REVISED DIRECT TESTIMONY AND EXHIBITS OF

ANTHONY M. SANDONATO

THE SOUTH CAROLINA OFFICE OF REGULATORY STAFF

IN RE: SOUTH CAROLINA ENERGY FREEDOM ACT (HOUSE BILL 3659)

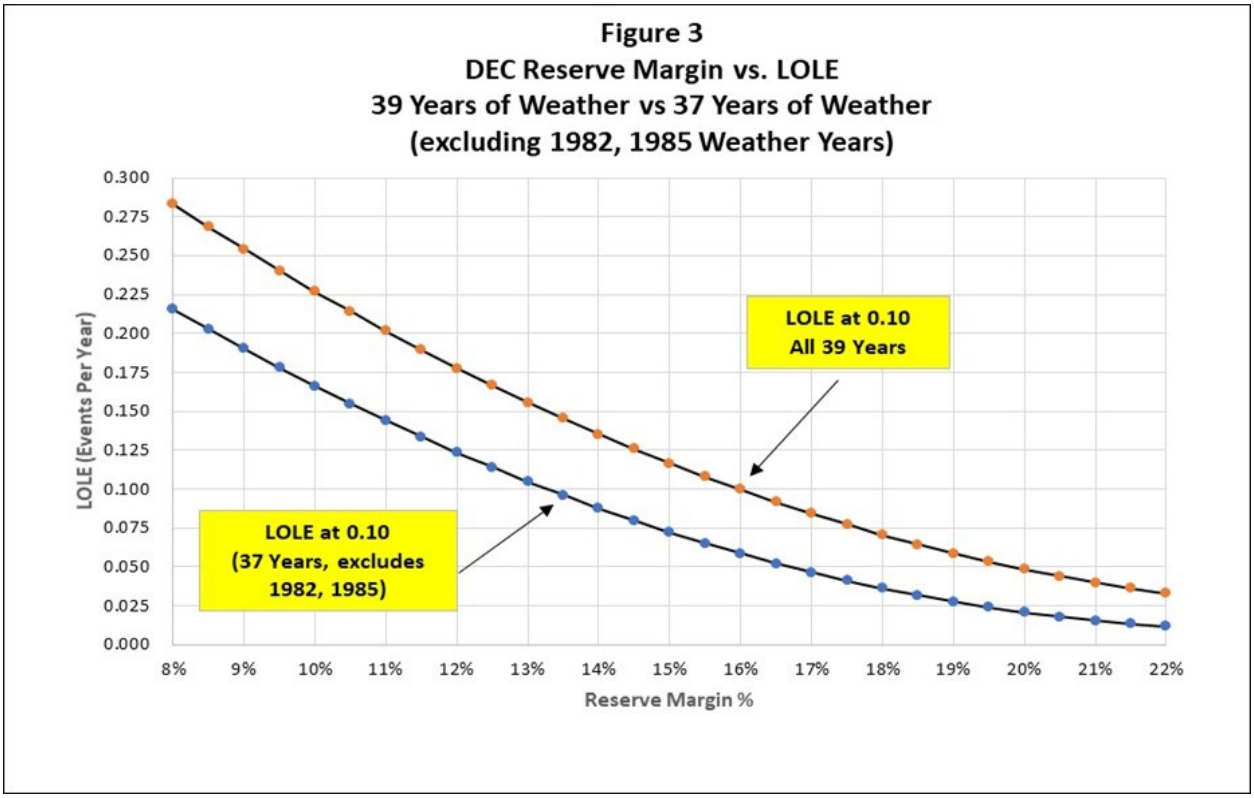
sensitive the SERVM resource adequacy results are to just a couple of years of extreme low temperatures out of the full 39-year period. While ORS did not attempt to calculate the effect on the combined DEP/DEC reserve margin using only 37 years of weather data, it is likely that a similar reduction in the required winter peak reserves would be produced. Figure 3 provides a comparison of the LOLE curves based on the full 39 years of weather (1980 – 2018) and 37 years of weather (excluding weather for the years 1982 and 1985).

ORS also reviewed other inputs in the LOLE analysis, including the neighboring utility tie-line support that is assumed to be available during emergencies. The SERVM analysis assumed emergency support from seven interconnected utilities and regions, not including support from DEP. The analysis developed 39-year load-weather relationships for each of these neighboring utilities so that the SERVM Monte Carlo analysis would measure the load diversity of these external sources under varying weather conditions. This is an attempt to reflect that fact that weather patterns tend to be regional. For example, during extreme cold weather on the DEC system or on the combined DEP/DEC system (which is actually used to set the reserve margin in this 2020 IRP), other neighboring utility systems may also experience extreme cold weather, limiting the availability of otherwise available emergency imports. The model attempts to portray such dependencies. The is a significant modeling enhancement, which would appear to increase the ability of the analysis to reflect likely events during extreme low temperatures.

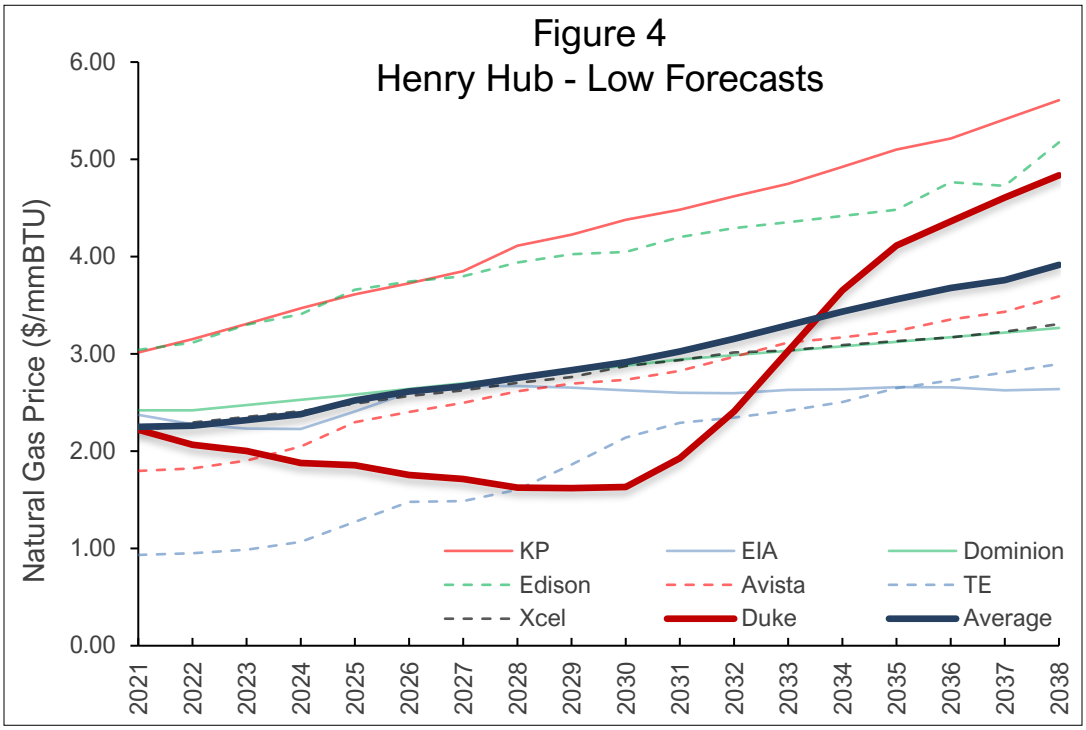
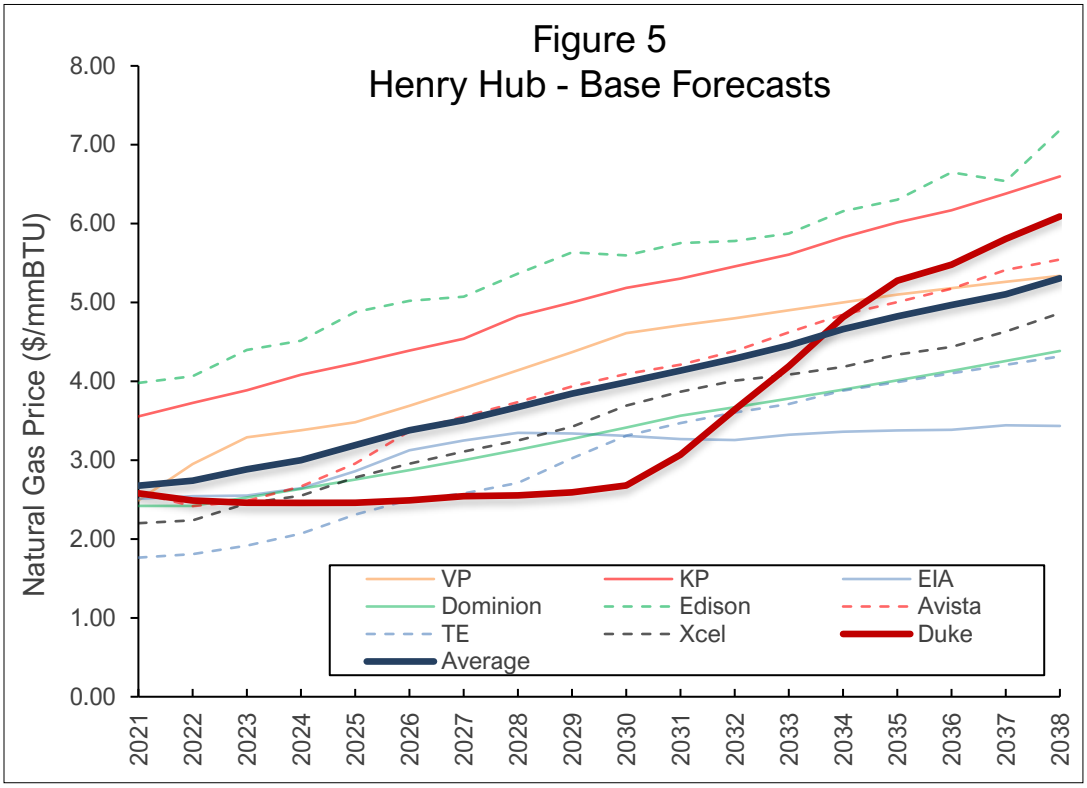
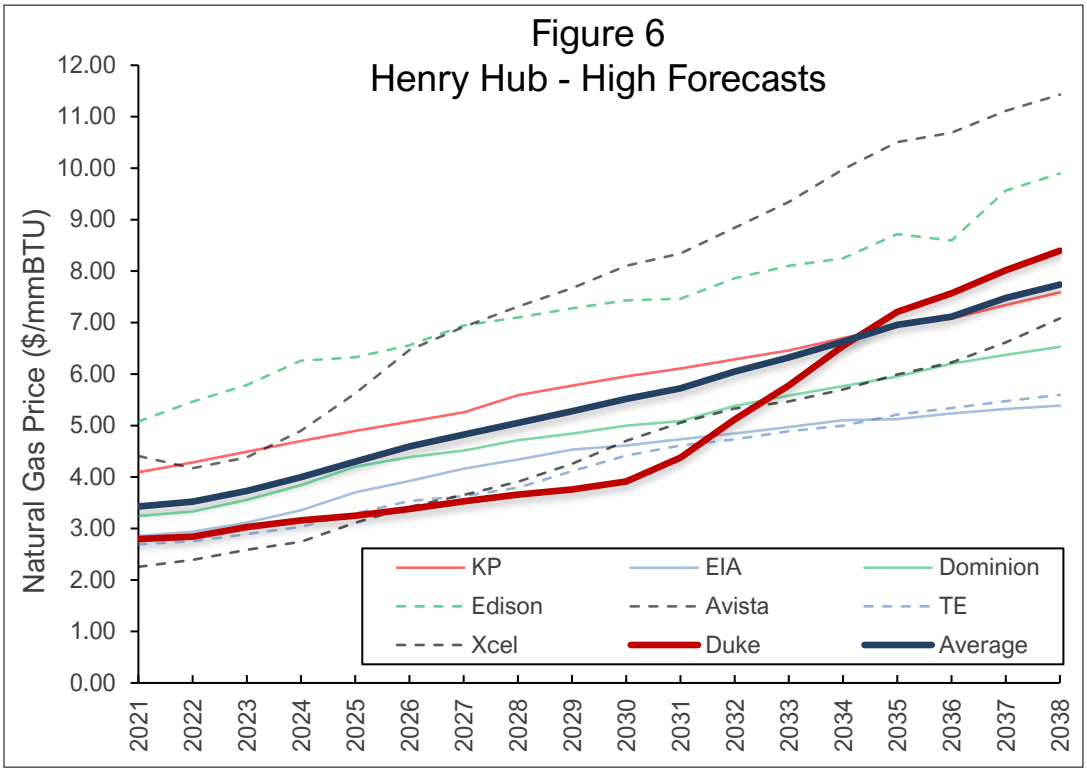
The Company's gas price forecasts are consistently lower than the consensus forecasts in all three (3) cases by a small amount over the period of 2021 to about 2035. After that the DEC forecast actually exceeds the consensus forecast by a small amount in all three (3) cases. ORS recognizes that the future is unknown and that natural gas price forecasts have been lowered considerably over the last ten years. While DEC's forecasts do appear to be a little low over the planning horizon, the important question is whether DEC's forecasts are outliers when compared to the other forecasts, and the answer is no. Some of the other comparable forecasts are actually lower or are close to DEC's forecast over the planning horizon.

While DEC's forecasts do not appear to be unreasonable, there may be an opportunity for improvement. The development of the Company's base gas price forecast is illustrated in the following graph, which shows that the DEC Base forecast is equivalent to the market forecast (NYMEX) until 2030, this trends into the fundamental forecast (IHS Markit) until 2035, and follows the fundamental forecast thereafter.

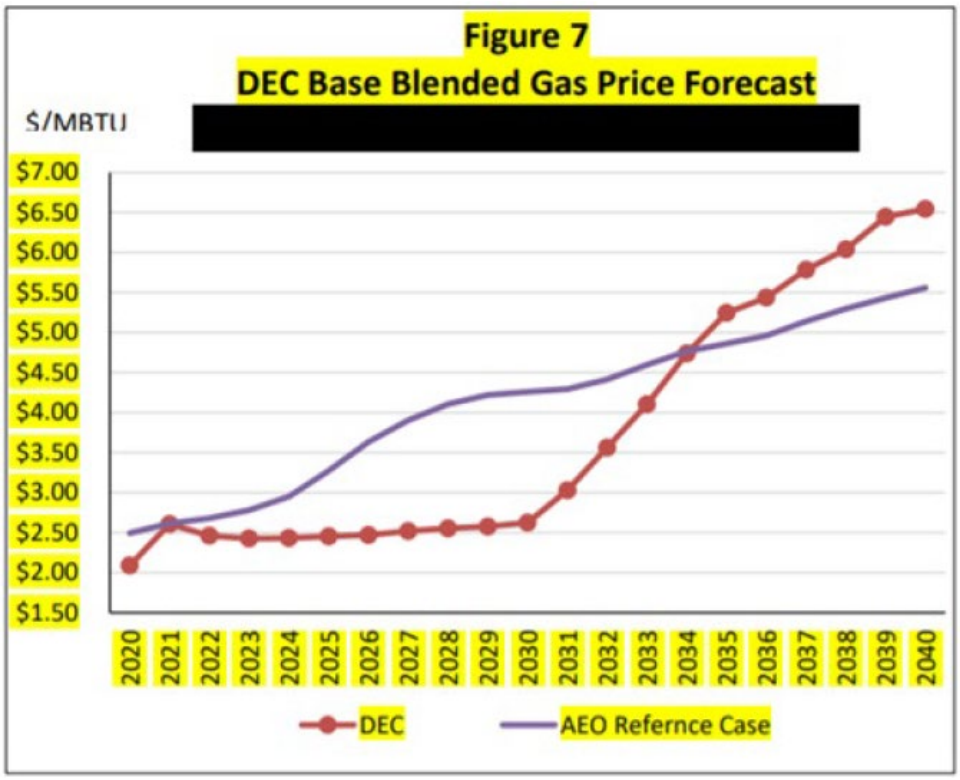
There are a few noticeable issues regarding the Company's forecast including the fact that it is rather flat for about ten years. The Company appears confident that based on actual market quotes it can lock in its gas supply for its entire system for the next ten years, which in our experience would be unusual for an electric utility to do. Second, even the Company's own fuel forecast vendor and EIA appear to have a different view of how natural gas prices will increase over time, and those two forecasts are largely consistent.

We point these concerns out because low gas price forecasts could result in indicating that natural gas-fired resources are comparatively less expensive than they otherwise would be relative to other resource alternatives. As an example, assuming a combined cycle unit has a 6.5 MBTU/MWh average heat rate, the dispatch price of that unit in 2030, when comparing the Company's gas price forecast estimate to the EIA AEO estimate, would be $17.06/MWh versus $27.68/MWh, respectively, which amounts to over a 60% difference in dispatch price, which certainly would favor gas-fired resources.

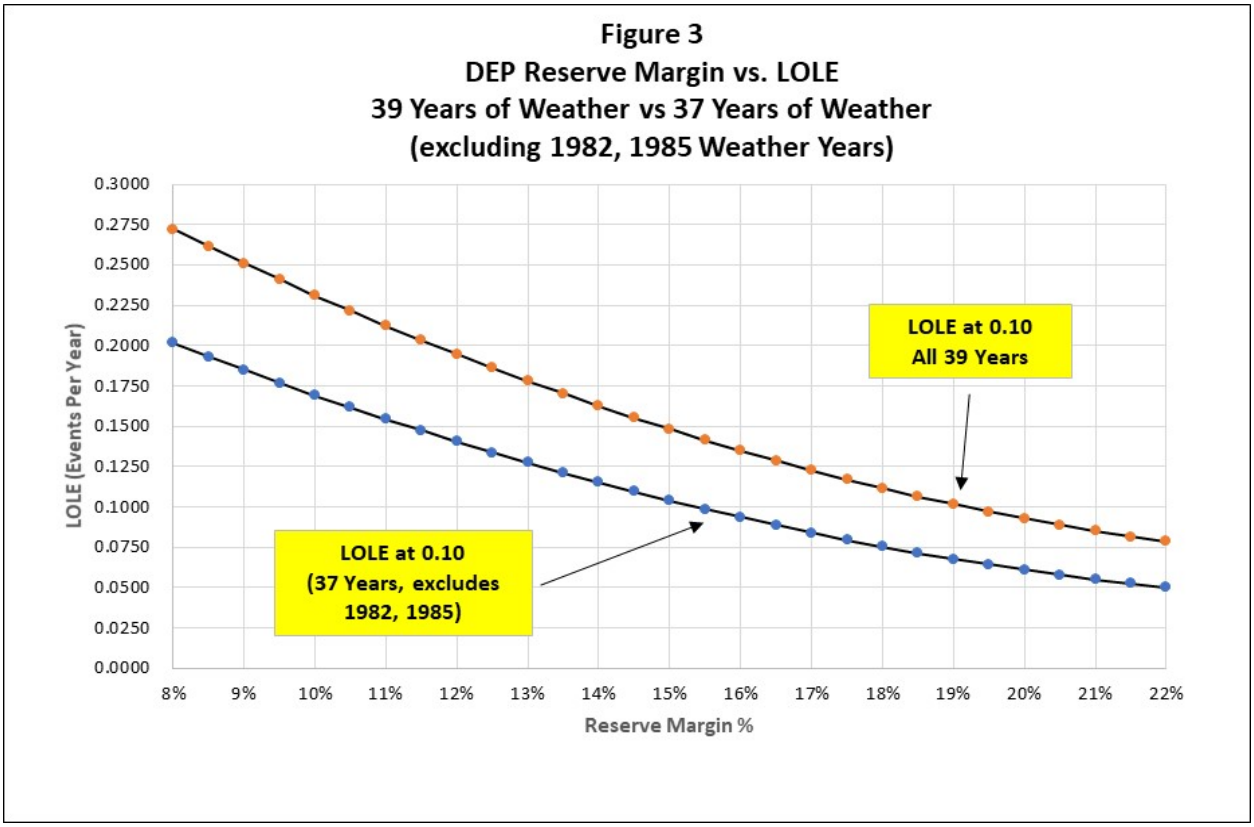
study for DEP using a full 39-year weather data set. The ORS analysis demonstrates how sensitive the SERVM resource adequacy results are to just a couple of years of extreme low temperatures out of the full 39-year period. While ORS did not attempt to calculate the effect on the combined DEP/DEC reserve margin using only 37 years of weather data, it is likely that a similar reduction in the required winter peak reserves would be produced. Figure 3 provides a comparison of the LOLE curves based on the full 39 years of weather (1980 – 2018) and 37 years of weather (excluding weather for the years 1982 and 1985).

ORS also reviewed other inputs in the LOLE analysis, including the neighboring utility tie-line support that is assumed to be available during emergencies. The SERVM analysis assumed emergency support from seven interconnected utilities and regions, not including support from DEC. The analysis developed 39-year load-weather relationships for each of these neighboring utilities so that the SERVM Monte Carlo analysis would measure the load diversity of these external sources under varying weather conditions. This is an attempt to reflect that fact that weather patterns tend to be regional. For example, during extreme cold weather on the DEP system or on the combined DEP/DEC system (which is actually used to set the reserve margin in this 2020 IRP), other neighboring utility systems may also experience extreme cold weather, limiting the availability of otherwise available emergency imports. The model attempts to portray

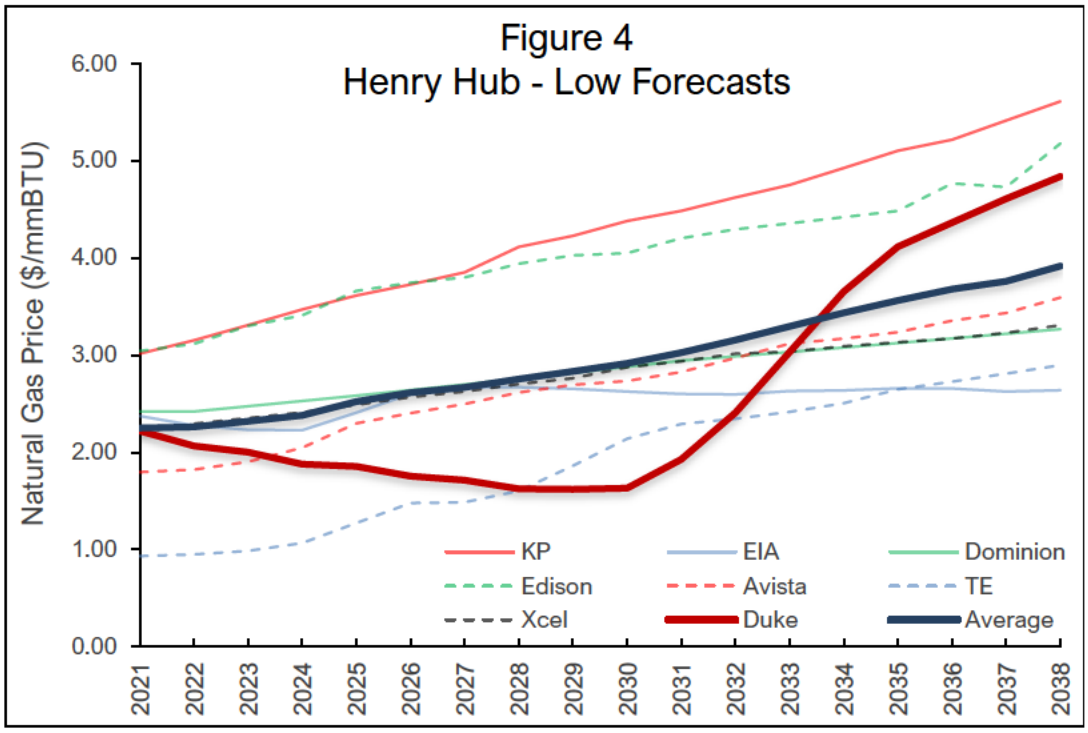
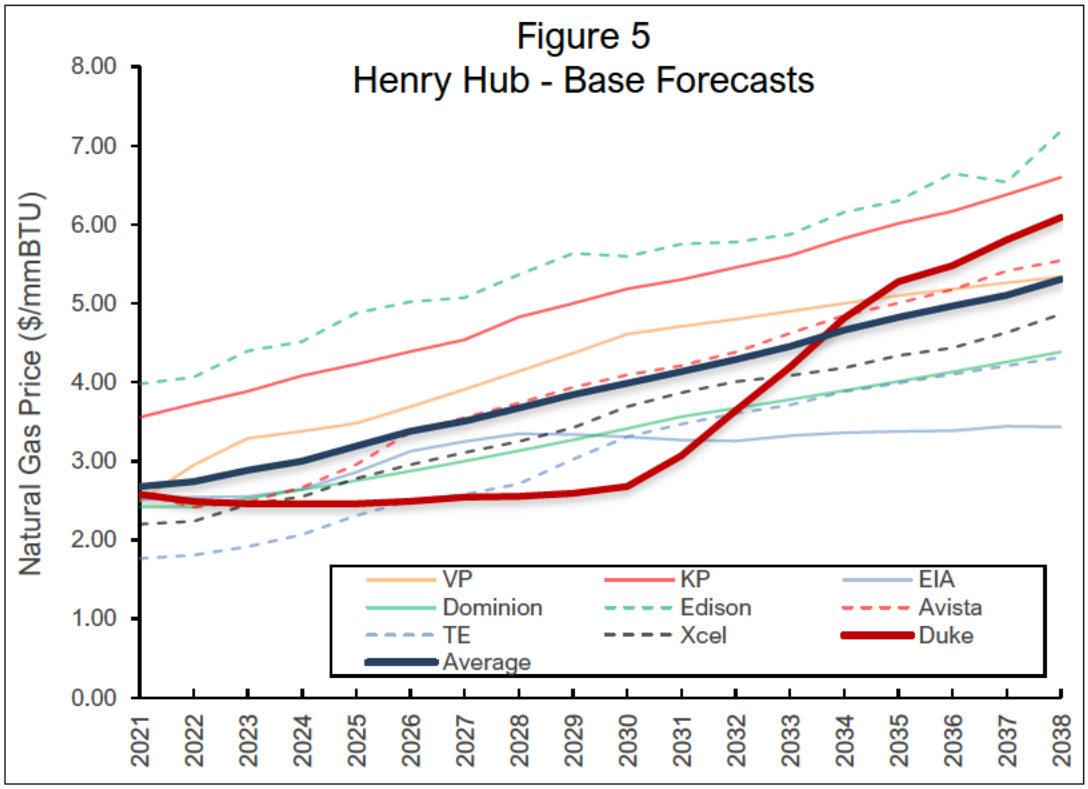
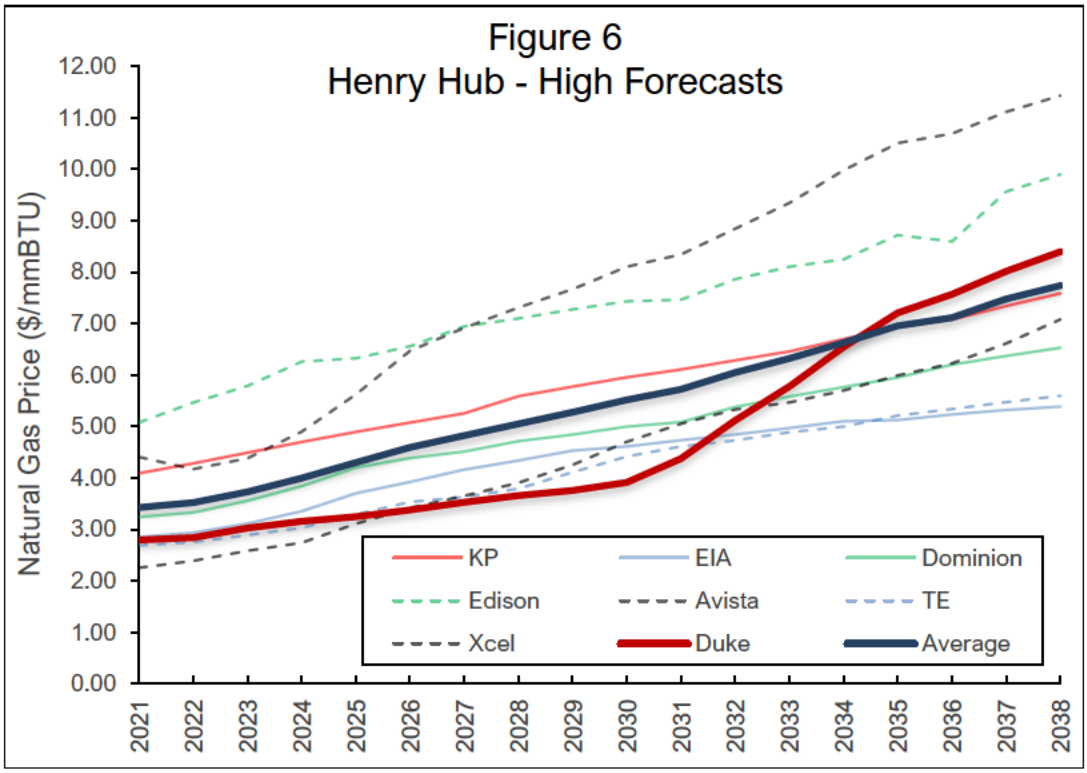
The Company's natural gas price forecasts are consistently lower than the consensus forecasts in all three (3) cases by a small amount over the period of 2021 to about 2035. After that the DEP forecast actually exceeds the consensus forecast by a small amount in all three (3) cases. ORS recognizes that the future is unknown and that natural gas price forecasts have been lowered considerably over the last ten years. While DEP's forecasts do appear to be a little low over the planning horizon, the important question is whether DEP's forecasts are outliers when compared to the other forecasts, and the answer is no. Some of the other comparable forecasts are actually lower or are close to DEP's forecast over the planning horizon.

While DEP's forecasts do not appear to be unreasonable, there may be an opportunity for improvement. The development of the Company's base gas price forecast is illustrated in the following graph, which shows that the DEP Base forecast is equivalent to the market forecast (NYMEX) until 2030, then trends into the fundamental forecast (IHS Markit) until 2035, and follows the fundamental forecast thereafter.

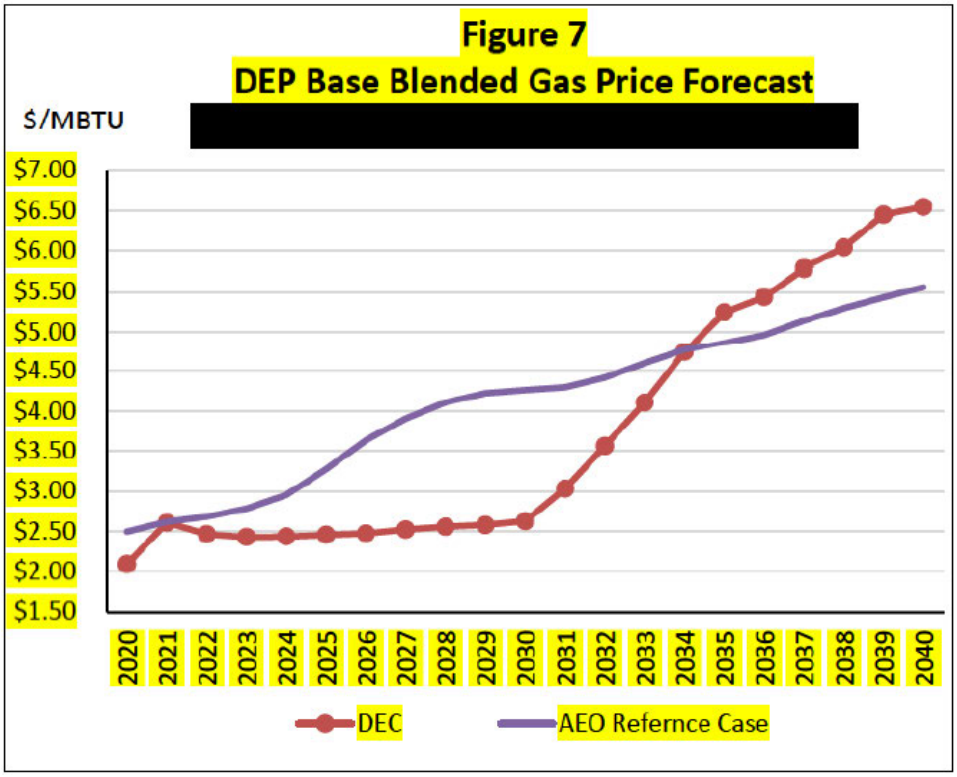
There are a few noticeable issues regarding the Company's forecast including the fact that it is rather flat for about ten years. The Company appears confident that based on actual market quotes it can lock in its gas supply for its entire system for the next ten years, which in our experience would be unusual for an electric utility to do. Second, even the Company's own fuel forecast vendor and EIA appear to have a different view of how natural gas prices will increase over time, and those two forecasts are largely consistent.

We point these concerns out because low gas price forecasts could result in indicating that natural gas-fired resources are comparatively less expensive than they otherwise would be relative to other resource alternatives. As an example, assuming a combined cycle unit has a 6.5 million British Thermal Units (MBTU)/MWh average heat rate, the dispatch price of that unit in 2030, when comparing the Company's gas price forecast estimate to the EIA AEO estimate, would be $17.06/MWh versus $27.68/MWh, respectively, which amounts to over a 60% difference in dispatch price, which certainly would favor gas-fired resources.
